RE: Proposed Change
Madison County Mississippi Circuit Court Building Renovation and Addition
Madison County Board of Supervisors
JHH No.: 23132

Re.: PN: 23132 Madison County Mississippi Circuit Court Building Renovations and Addition | PCO #3

TEMPORARY COURT FACILITIES

9 JUDGE'S BENCH - SECTION
SD.A2 1 1/2" = 1'-0"

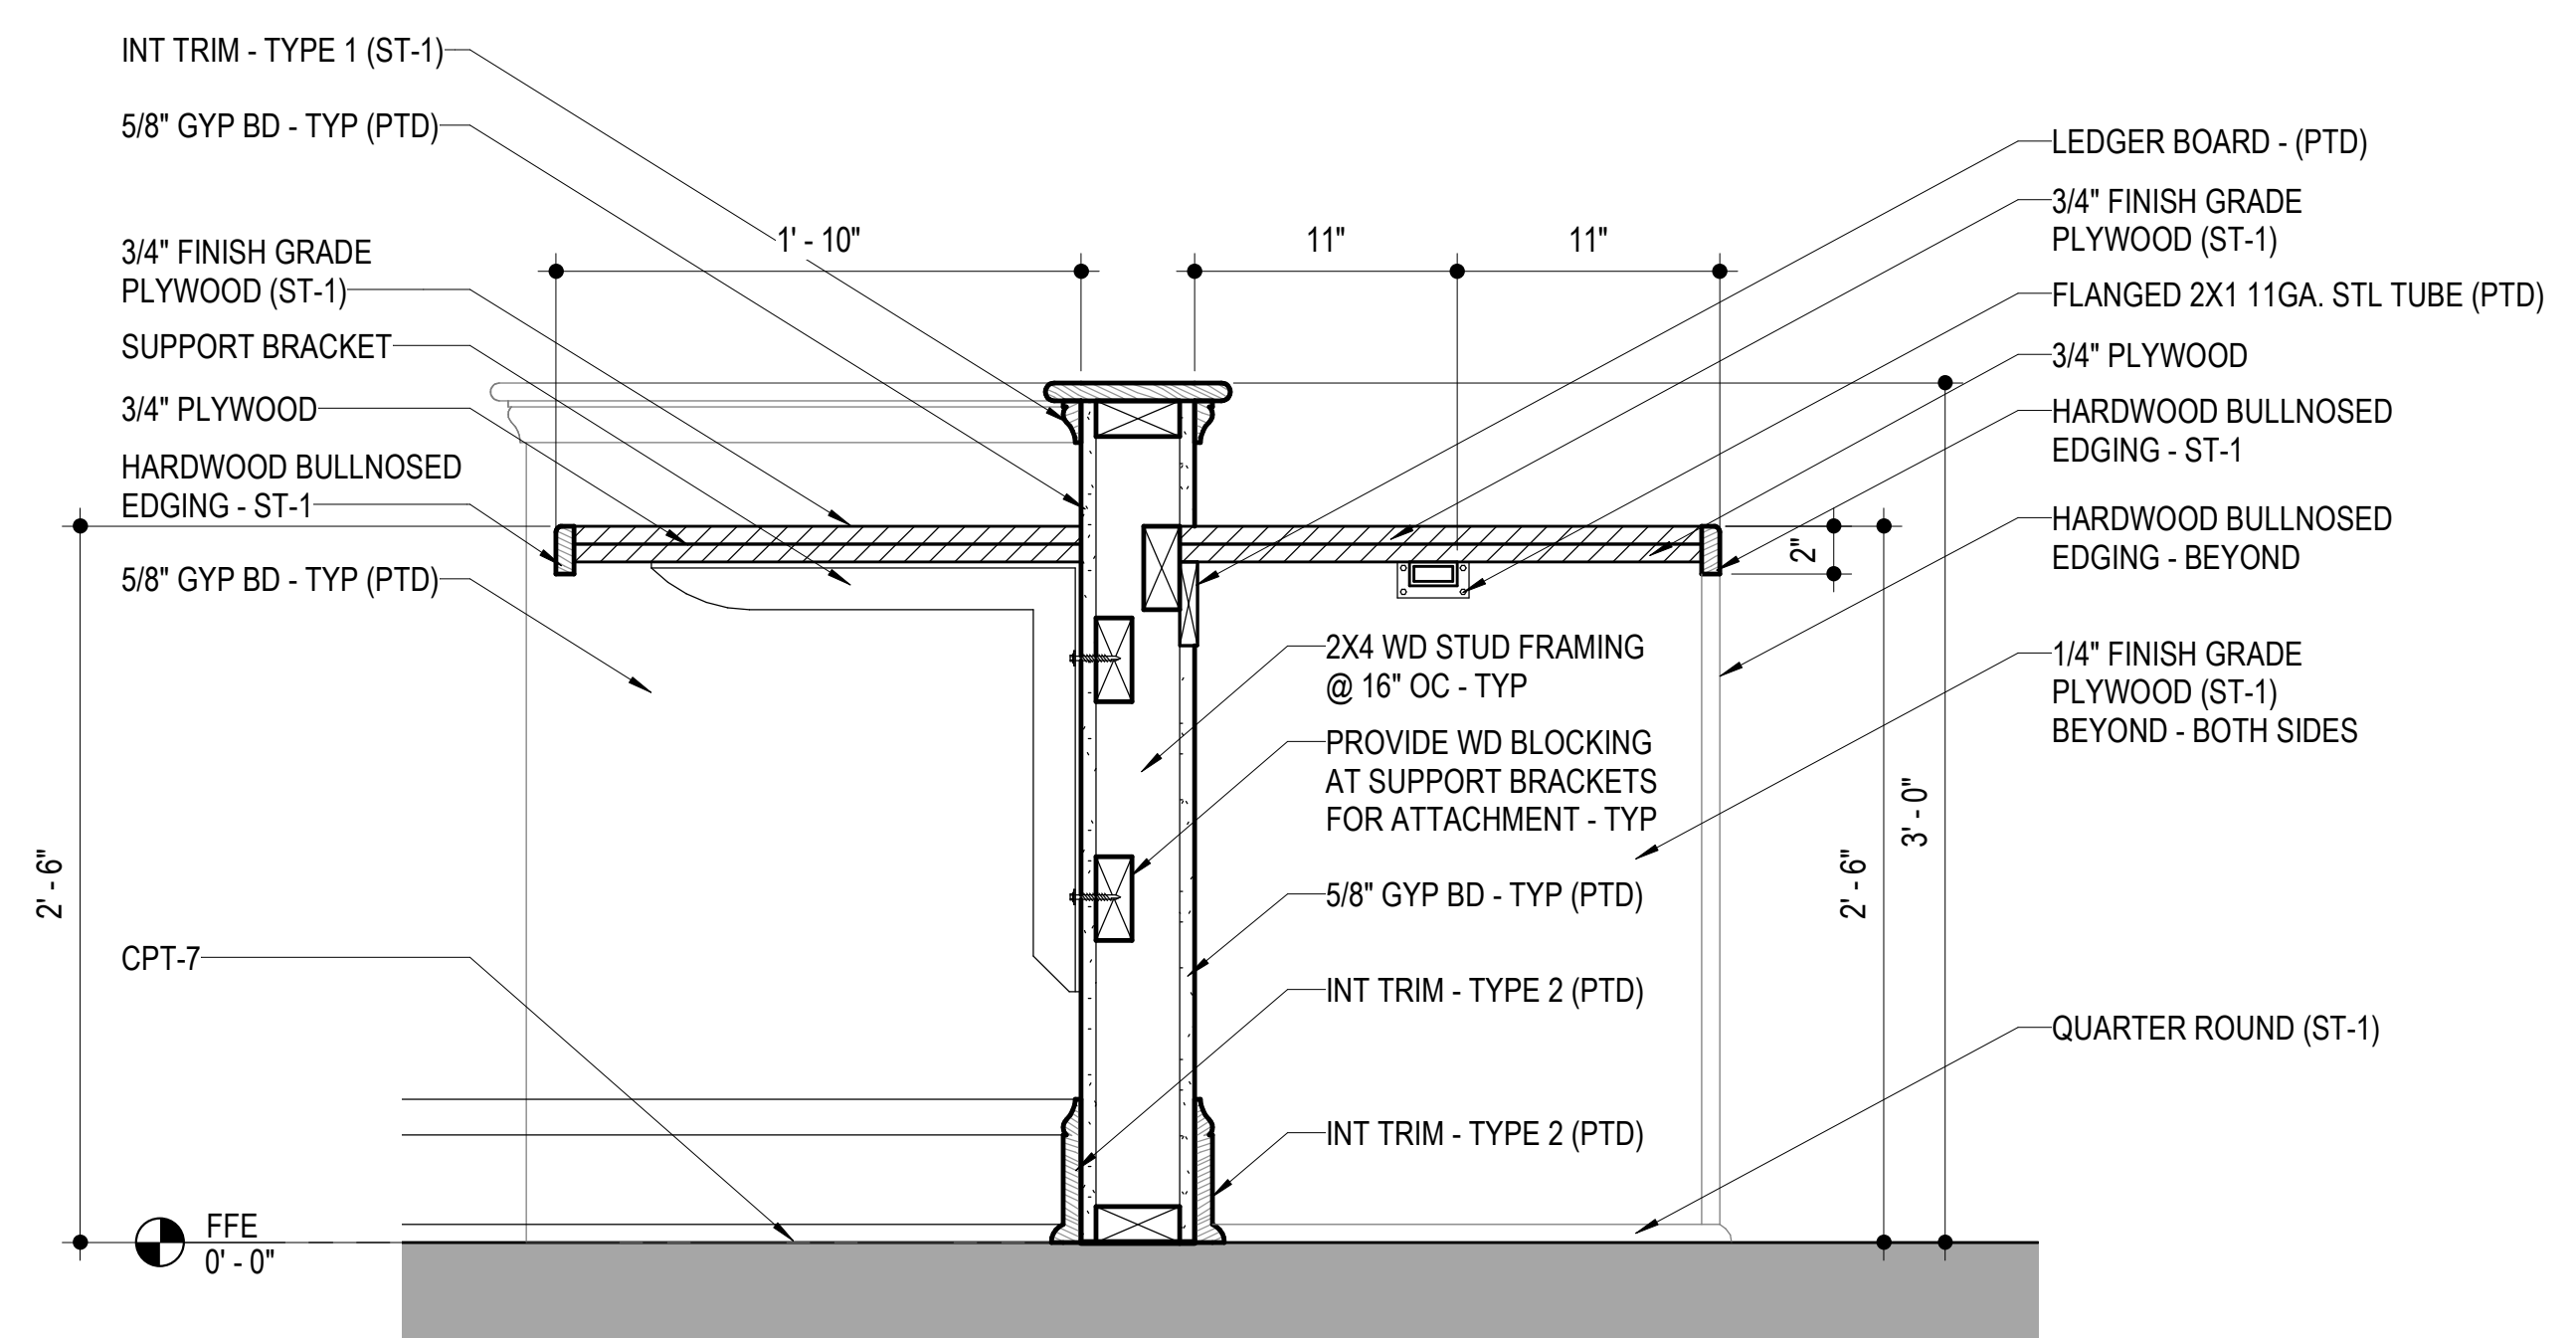
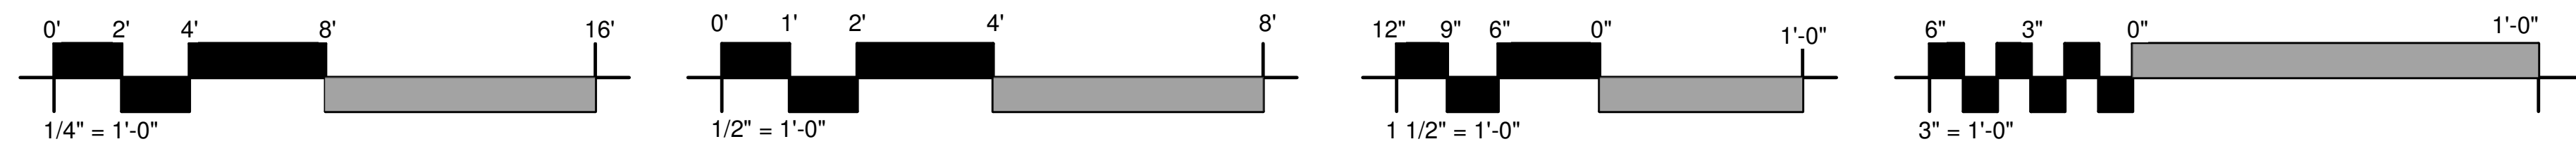
The following is the proposed change order price to provide all labor and materials necessary to complete the construction of the new Judge's Bench and Gallery Wall as shown on drawing SD.A2 dated 12/15/25. This price also includes the labor to modify the existing pews.
